MONTGOMERY COUNTY HISTORIC PRESERVATION COMMISSION STAFF REPORT

Address: 5918 Cedar Pkwy., Chevy Chase Meeting Date: 9/19/2018

Case Number: 35/13-18CC

PROPOSAL: Dormer installation

Detail: Approximate locations of where the two new dormers will be located.

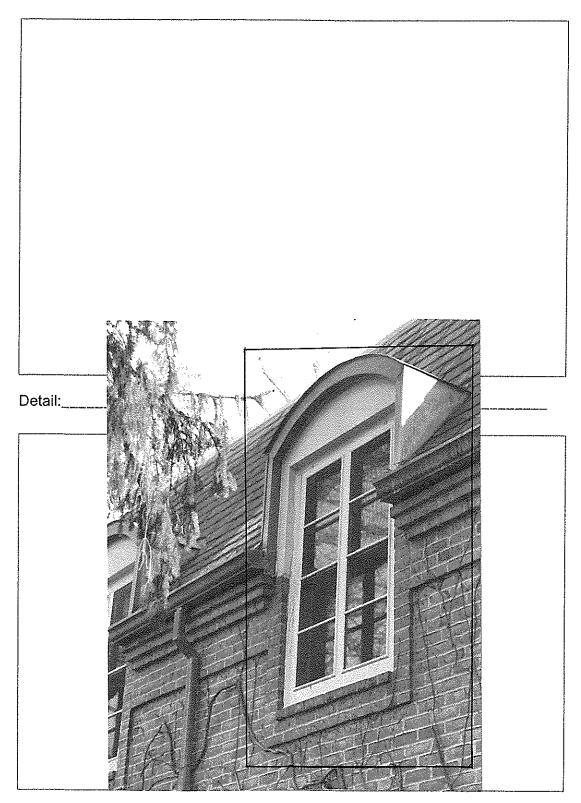
The subject property is a c. 1976 modern Georgian-style brick house with slate roof. The house is square-shaped and faces east, with forward projecting wings to the north and south. The applicant proposes to install two evenly-spaced arched dormers on the south elevation of the southern forward projecting wing.

The southern forward projecting wing is 1 ½-story with mansard roof. The proposed dormers will take visual cues from three existing evenly-spaced arched dormers on the north elevation of the northern forward projecting wing. The proposed materials for the new dormers include paintable composite panel siding (Azek), field-turned copper roofing, and aluminum-clad SDL casement windows. The windows will have permanently-affixed interior and exterior 7/8" profile muntins with internal spacer bars.

The proposed alterations are generally compatible with the subject house and are on a secondary elevation, where they are less visible from the public right-of-way. The proposal will not affect the scale and massing of the subject house or detract from the surrounding streetscape. In accordance with the *Guidelines*, the proposal should be approved as a matter of course.

Staff recommends that the Commission <u>approve</u> the HAWP application under the Criteria for Issuance in Chapter 24A-8(b), having found that the proposal is consistent with the *Chevy Chase Village Historic District Guidelines* identified above, and therefore will not substantially alter the exterior features of the historic resource and is compatible in character with the district and the purposes of Chapter 24A;
